Application for Licence

| Licence Number | L9430/2024/1 |
| Applicant | Onslow Iron Pty Ltd |
| Premises | West Pilbara Iron Ore Project M08/480, M08/484, G08/88, L08/67, L08/68, L08/69 and L08/181 CANE WA 6710 As defined by the premises maps attached to the issued licence |

Figure 3: Relationship between SAR and EC of irrigation water for prediction of soil structural stability

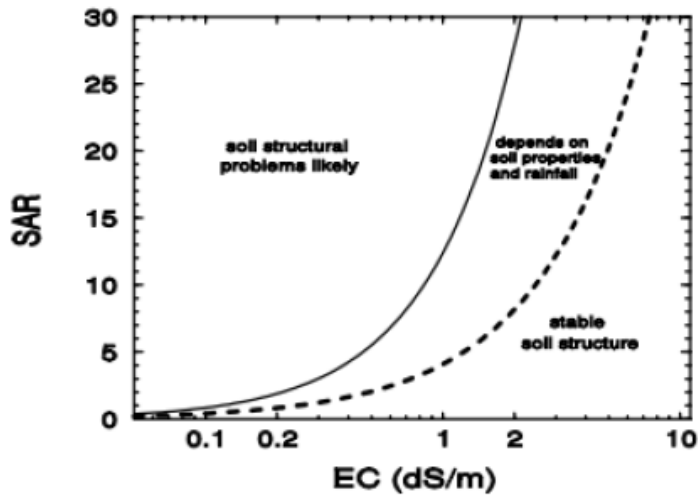
Limited data has been provided on blended effluent quality (Table 3), therefore SAR has been calculated using the upper range of RO simulation data as outlined in Table 2 (for Na, Ca and Mg). This results in a calculated SAR value of 4.28. When compared with the EC of the discharge (lower and upper ranges from Table 2 and 3) and plotted on the graph shown in Figure 3, the blended effluent is not considered likely to cause soil structural problems overtime.
